Elevating and Amusement Devices Safety Program	Ref. No.: 301 / 23
DIRECTOR'S SAFETY ORDER	Date: April 30, 2023

Re: Dover Counterweight Frame Cracks and Repair

INSTALLATION INSTRUCTIONS DOVER CWT REINFORCEMENT

Document No.: T17752-011, Rev -

"U" Type Crosshead
(top beam)

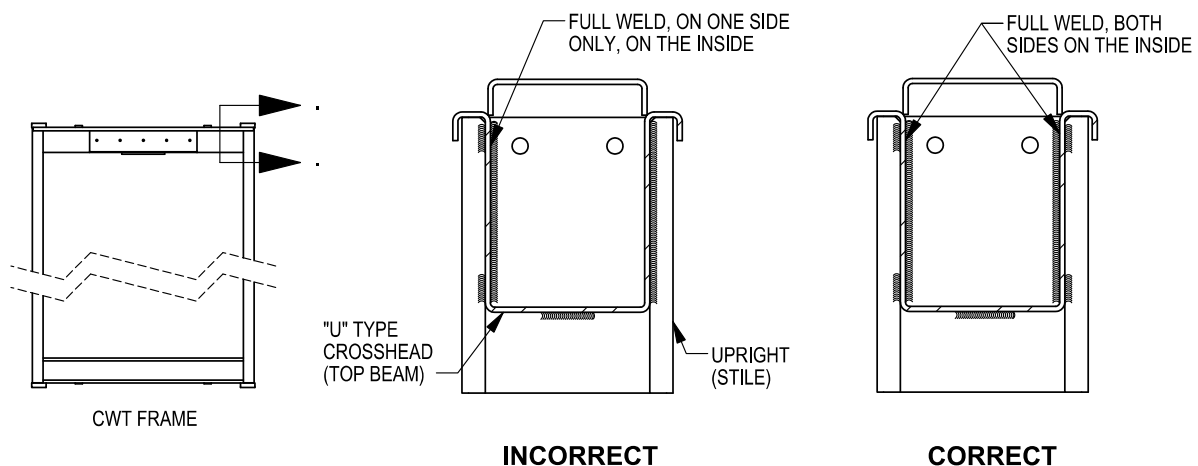
We recently found that some Dover-Turnbull Canada counterweight frames have developed cracks on the uprights (stiles) near the top weld with the crosshead. This is due high stresses developed in the cracked region because of asymmetrical welds between the crosshead and the upright.

When welded properly, the crosshead is welded to the upright by a full weld on each side on the inside of the crosshead web, and two intermittent (1in long) on the outside. The improperly welded crosshead will have only one side the crosshead web welded on the inside.

If the crosshead is welded incorrectly, it needs to be reinforced to prevent high stresses.

Inspect and apply retrofit if required.

Counterweight Frame

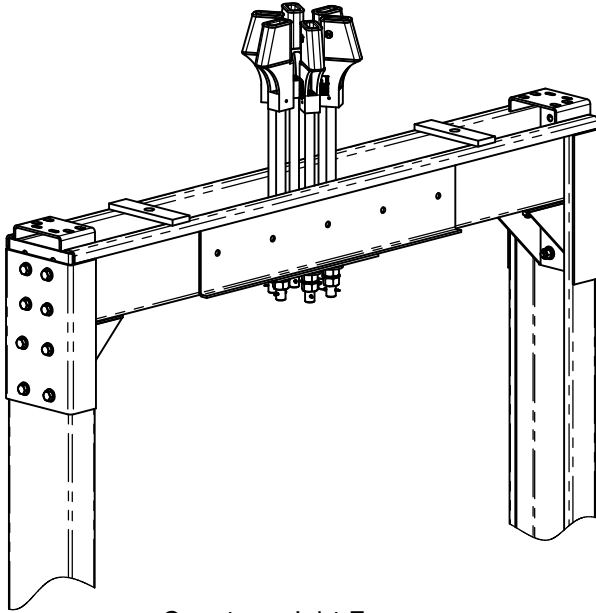
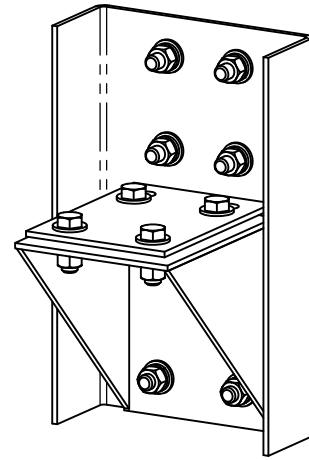
Install a reinforcement bracket kit #T17752-120 at the top corners of the CWT frame.

Reinforcement bracket.
See Kit #T17752-120

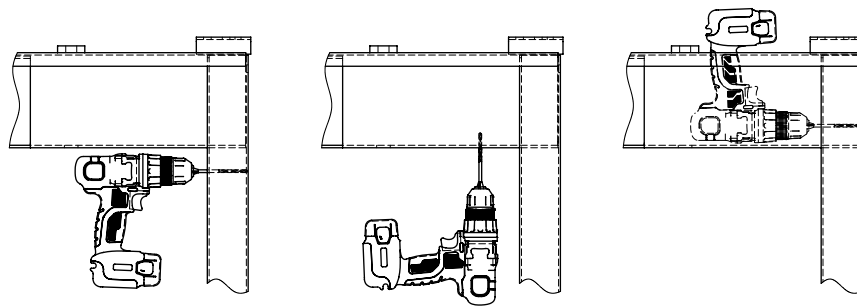
- 3.1. Without removing guiding means, use the angle-bracket as template and the drilling template provided to mark up the location of the holes to be drilled.

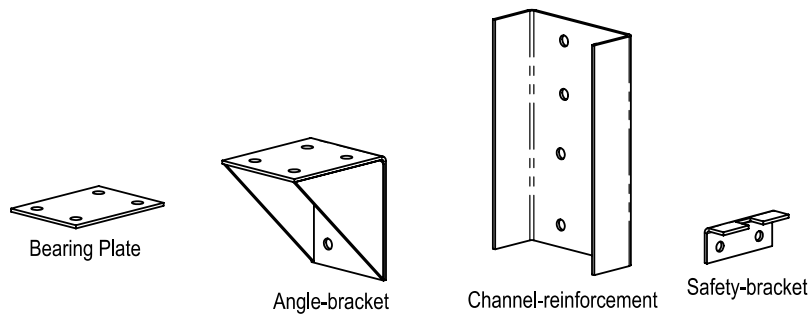
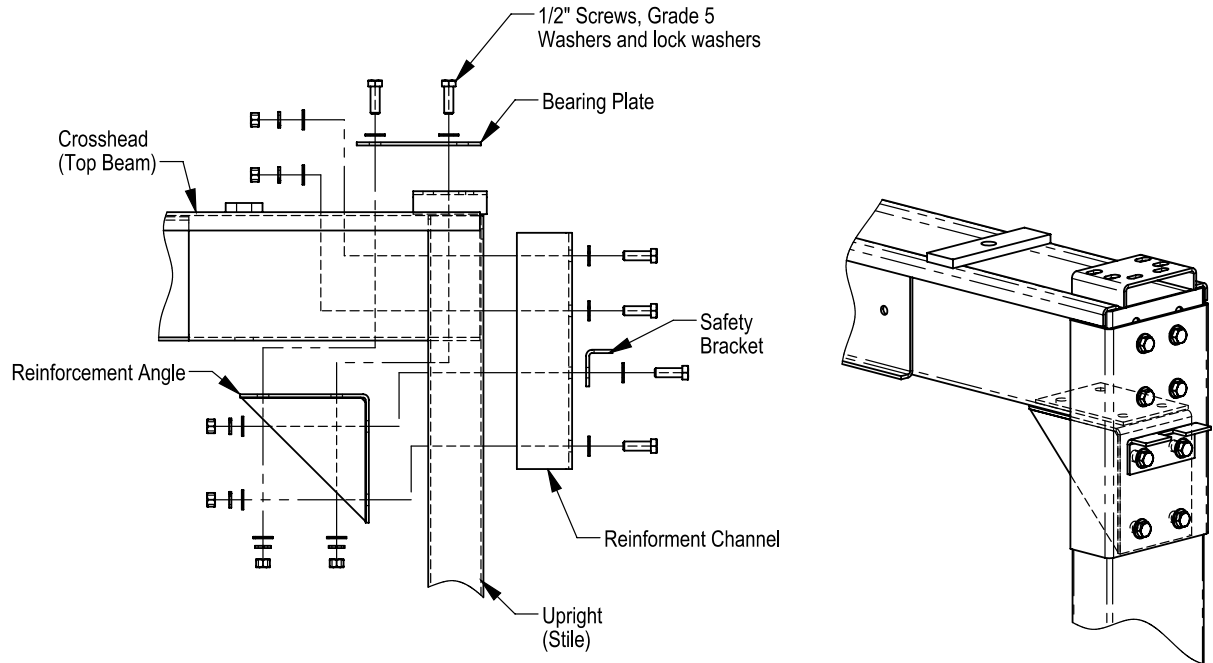
3.2. Drill 12X Ø9/16" (0.562") holes on the marked-up locations.

3.1. Install the Angle-Bracket, Channel-Reinforcement, Bearing-plate, and safety bracket as shown.

3.2. Repeat installation on the other side.
